3.2 Bloom Street

4.0 Design Changes

4.1 List of Design Changes

4.2 Space planning and compliancy

Bloom Street. Lower Ground Floor

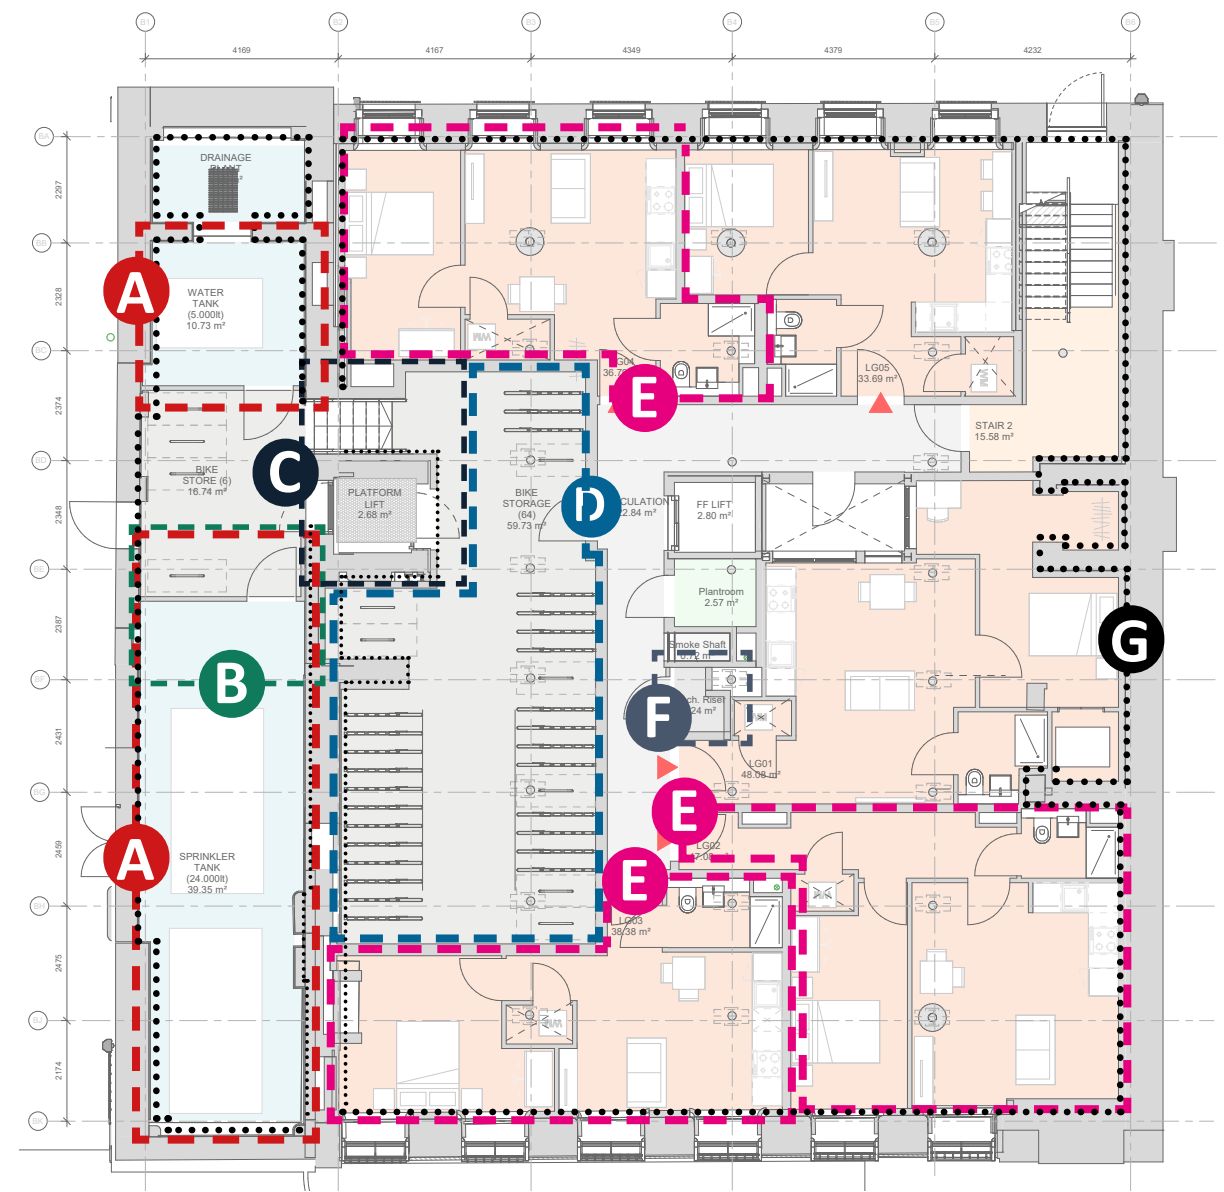
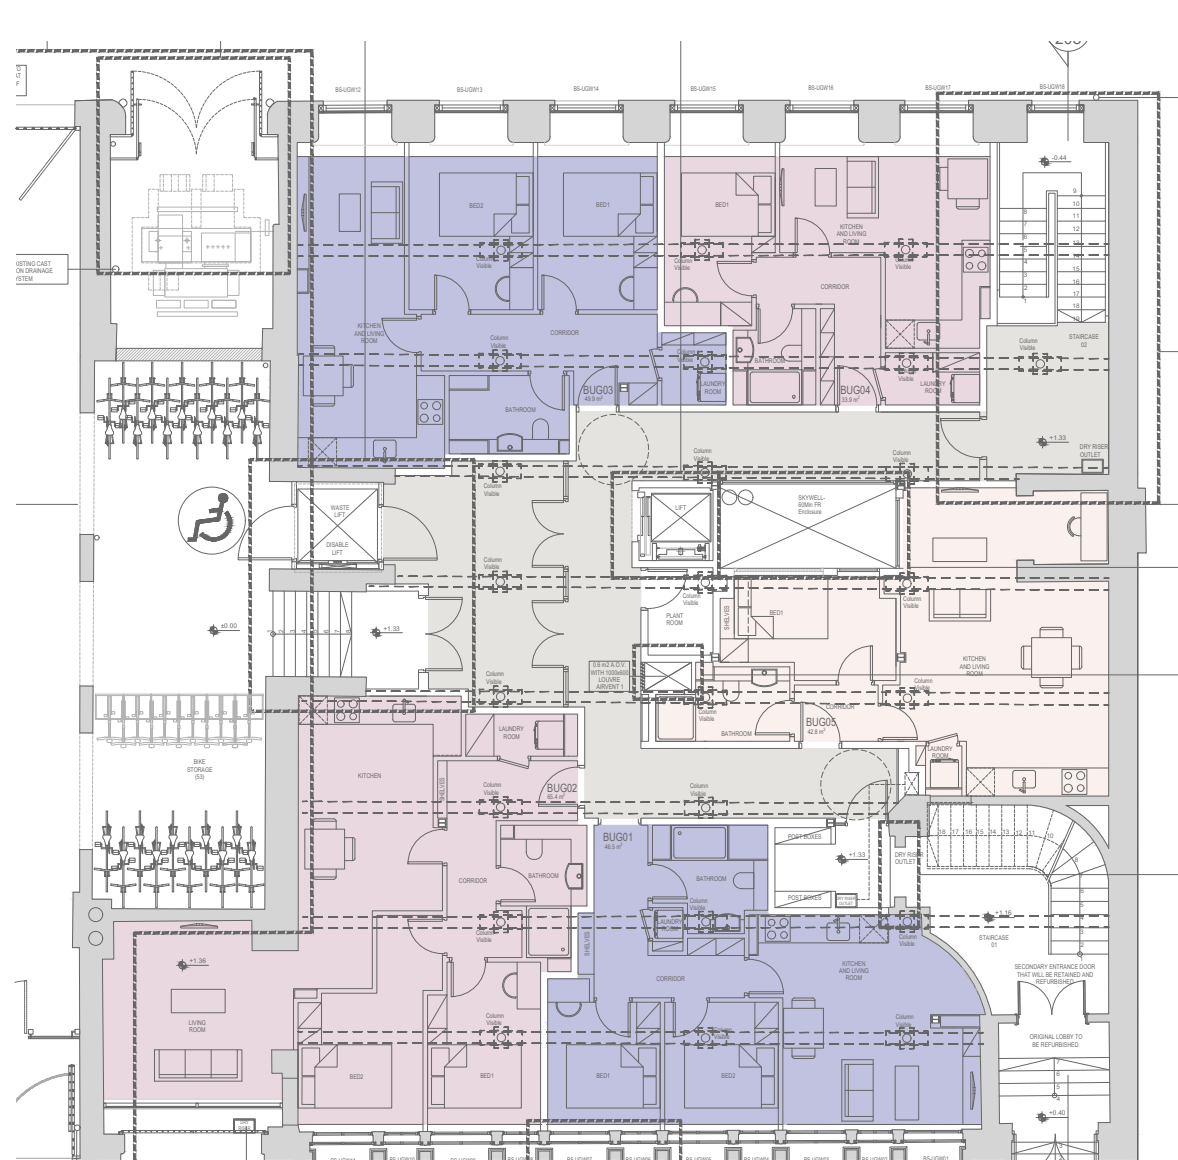
- Apartment layout: Improved efficiency and open plan arrangement where possible.
- New structural columns: Removal of 6x proposed steel H columns following structural proposal review.

- A** Basement area: Bin store relocated at external level and area used to locate sprinkler tanks for both buildings and water tank for Bloom Street.
- B** Basement masonry piers: partially demolished to allow location of sprinkler tanks.
- C** Platform lift and stair: Access to basement and lower ground floor redesigned to allow smoother access to facilities.
- D** Cycle store: expanded to provide 1x bike space per apartment

- E** Apartment layout: reconfigured and reduced in size to allow cycle store expansion. Number of bedrooms unvaried.
- F** Plantroom: Mechanical plant added for functional reasons.
- G** Tanking system

Bloom Street. Upper Ground Floor

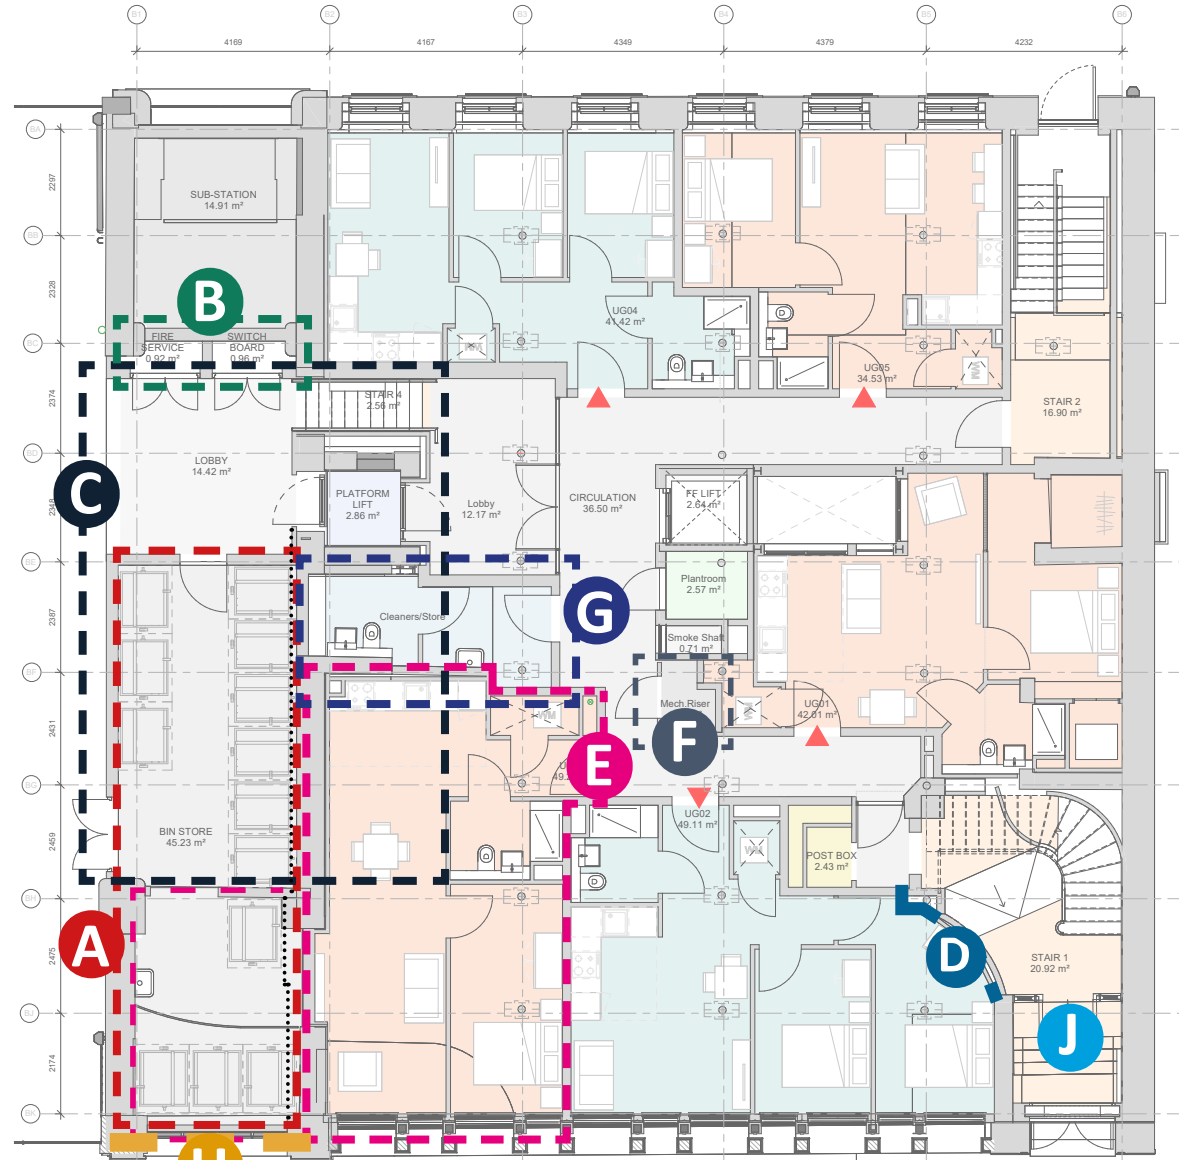
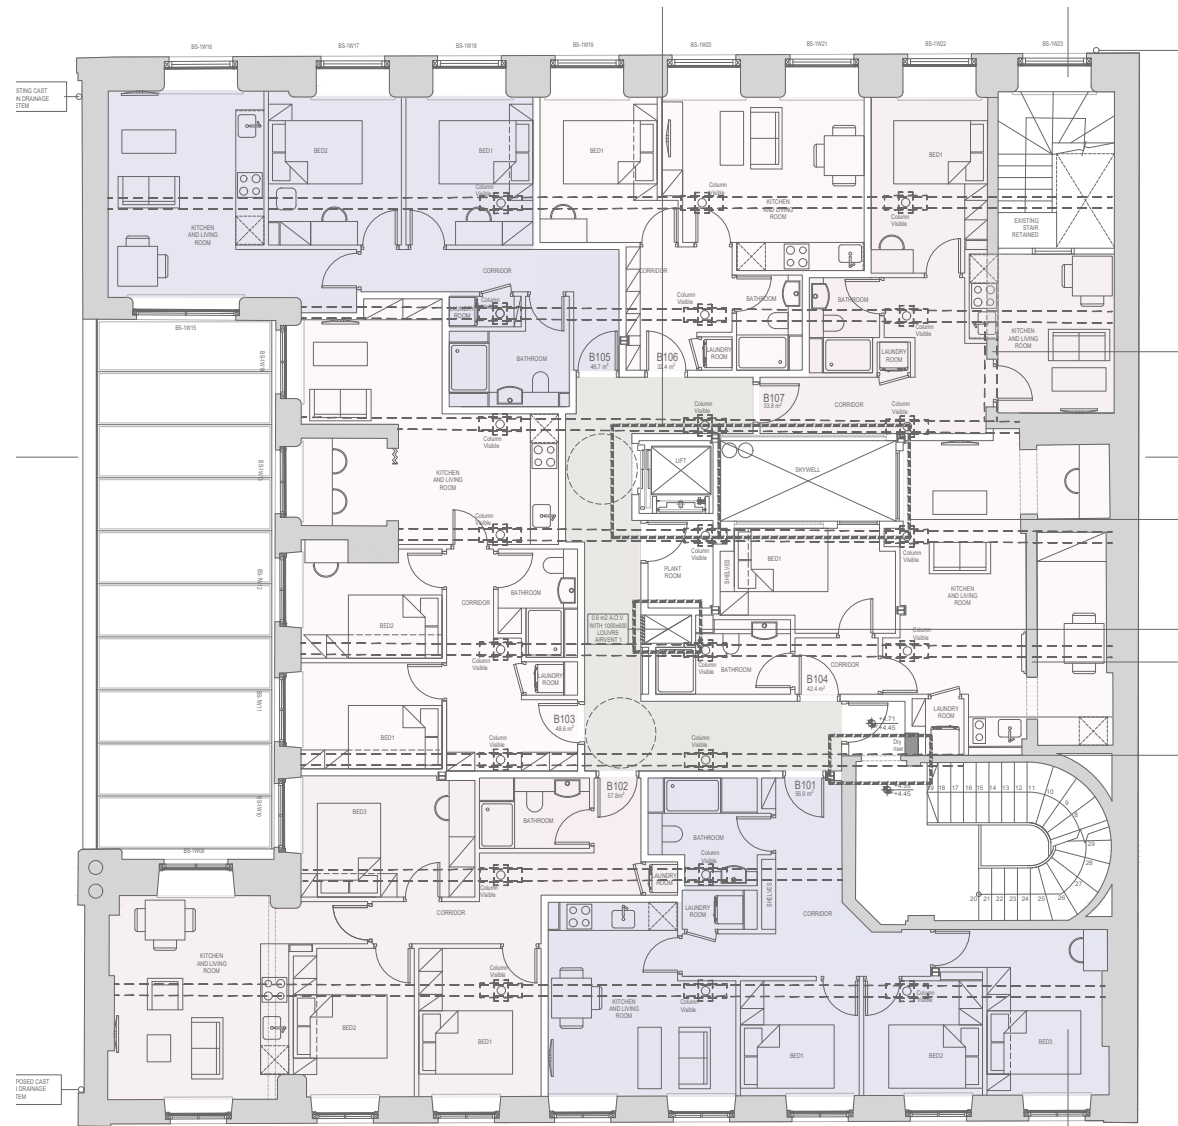
- Apartment layout: Improved efficiency and open plan arrangement where possible.
- New structural columns: Removal of 6x proposed steel H columns following structural proposal review.
- Main stair handrail: to be upgraded to comply with minimum height requirement. Additional top rail required possibly without interfering with original balustrade

- A** Relocated Bin Store: Located at external level with levelled access for residents and simplified waste management.
- B** Switchboard and fire service: Added to layout for functional reasons.
- C** Accessible entrance redesign. Now separated to cycle store and with dedicated lobby. External volume as per approved drawings.
- D** Fire rated plasterboard lining: introduced to provide tested fire compartmentations against existing elements.

- E** Apartment reconfiguration: Approved 2 Bedroom apartment redesigned to 1 Bedroom to create space to Bin Store.
- F** Plantroom: Mechanical plant added for functional reasons.
- G** Cleaners Store: Added to scheme
- H** Curtain walling redesign: Originally proposed fixed grid removed as detrimental from cleaning and maintenance of the area.
- J** Door opening outward (hinges to be reversed) to comply with fire escape requirements

Bloom Street. First Floor

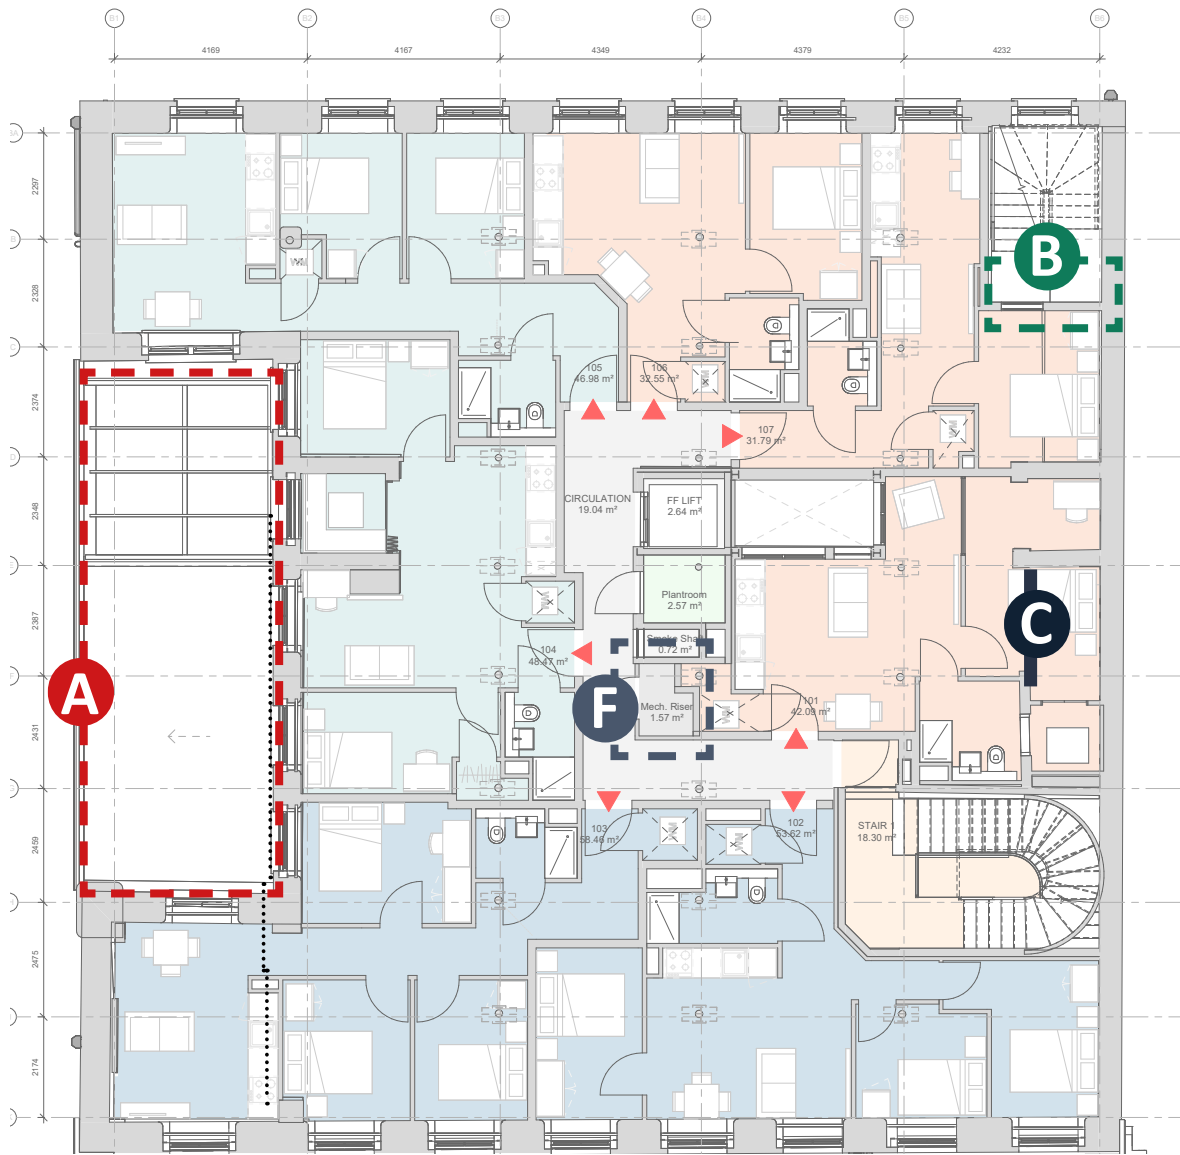
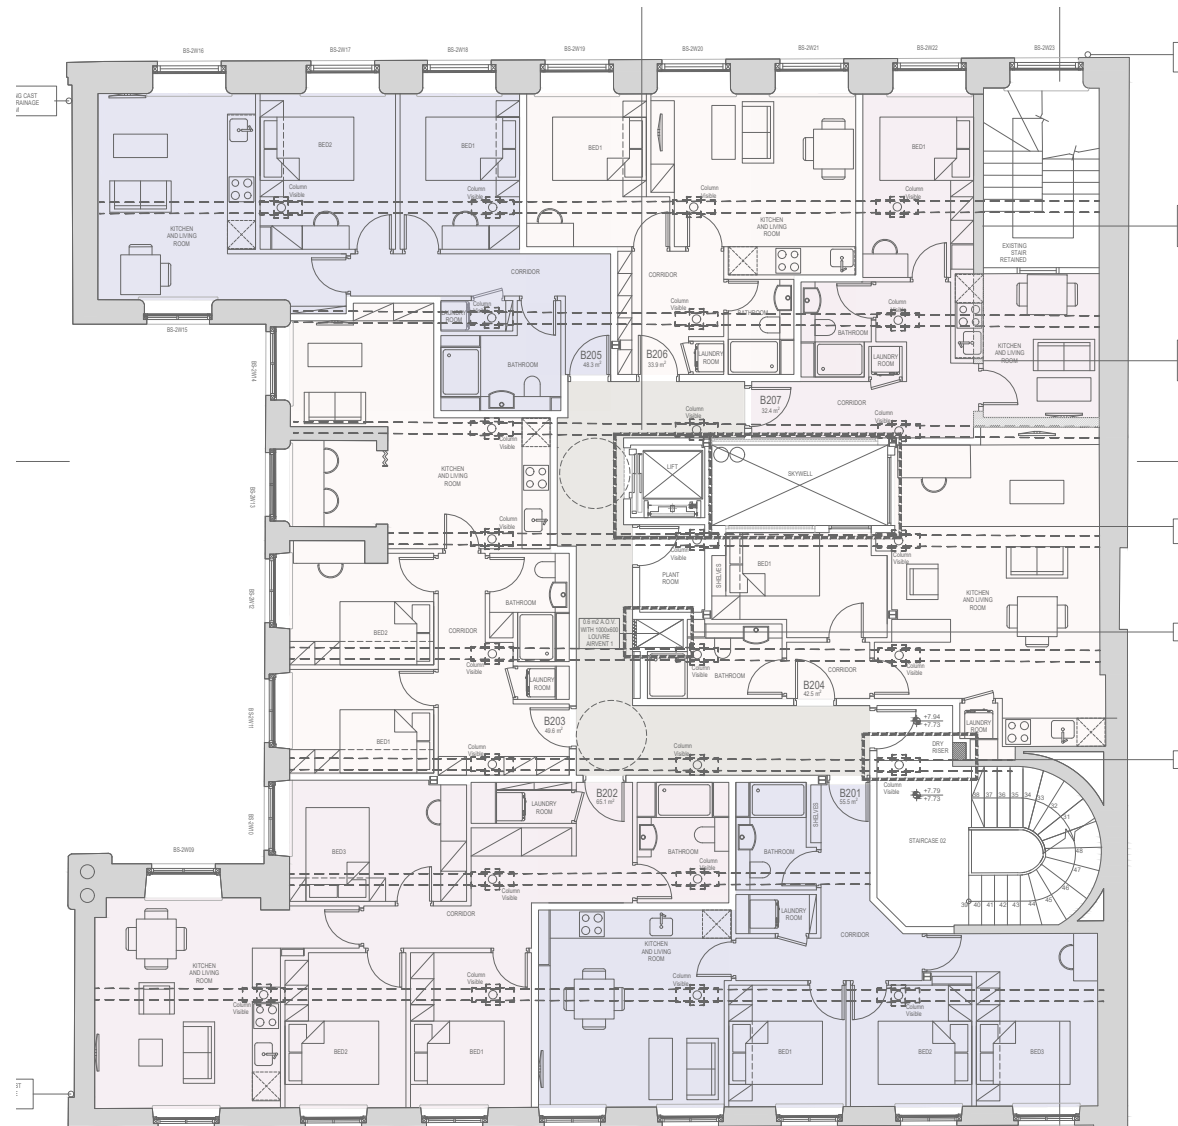
- Apartment layout: Improved efficiency and open plan arrangement where possible.
- New structural columns: Removal of 6x proposed steel H columns following structural proposal review.
- Main stair handrail: to be upgraded to comply with minimum height requirement. Additional top rail required possibly without interfering with original balustrade

- A** Alleyway extension roof: redesigned to be glazed above lobby and a pitch slated roof above bin store
- B** Rear stair landing: proposed for access ad maintenance (was removed in later GAs versions)
- C** Safe brickwall: proposed to be partially demolished to help with space planning.
- D** Plantroom: Mechanical plant added for functional reasons.
